## CITY OF GARDEN CITY

### STAFF REPORT

**File Number:** DSRFY2024 - 0013

New Construction of a Non-Residential Structure

*Picture 1.*

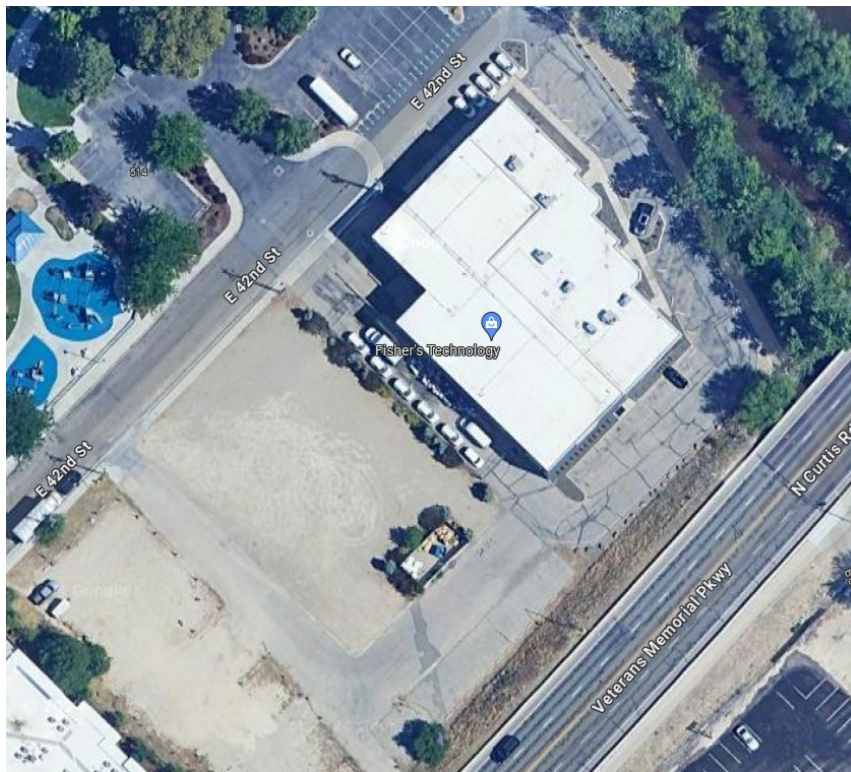
<a href="#">8-4A-7 Stormwater Systems</a>	DC/PZ/CC	Compliant as Conditioned		<p>Referring to the City Engineer's comment: The landowner must enter into an agreement with the city that will be recorded addressing mandatory maintenance of the site's storm water system. The agreement must be fully executed, have conditionally approved plans attached and be recorded by the city with final plan approval.</p> <p>A draft condition of approval has been provided requiring that the stormwater systems be built in compliance with provisions of 8-4A-7.</p>
<a href="#">8-4A-8 Utilities</a>	DC/PZ/CC	Compliant as Conditioned		<p>All utilities for a new structure shall be installed underground. For the purposes of this section, the term "utilities" shall include, but not be limited to, electric, natural gas, water, wastewater collection, storm drainage, telephone, and cable services. The Garden City Comprehensive Plan and the Ada County Hazard Mitigation Plan speaks to the importance of undergrounding utilities to help reduce the City's vulnerability during extreme weather events.</p> <p>As shown in the photograph provided by Brad McGirr in his public comment, there are overhead utilities running along the</p>

<p>entire frontage of the property on the E. 42nd Street side. (see <i>Picture1</i>)</p> <p>A draft condition of approval is provided requiring that all utilities be underground, including those existing along the E. 42<sup>nd</sup> right-of-way. So long as permission is granted by Idaho Power, and that in doing so does not create undue hardship.</p>
<a href="#">8-4A-9 Waterways</a>	DC/PZ/CC	Compliant as Conditioned	<p>There does not appear to be Boise River irrigation facilities at the site.</p> <p>The property located at E. 42<sup>nd</sup> Street does not contain areas identified as irrigation canals or ditches. No permission letter from Irrigation/Ditch Company Authorization Letter provided.</p> <p><b>There is a Fairview Acres lateral piped irrigation line running through the property. Permission/coordination with Fairview Acres for the streetscape will be required.</b></p>
<b><u>8-4C Design Provisions for Nonresidential Structures</u></b>
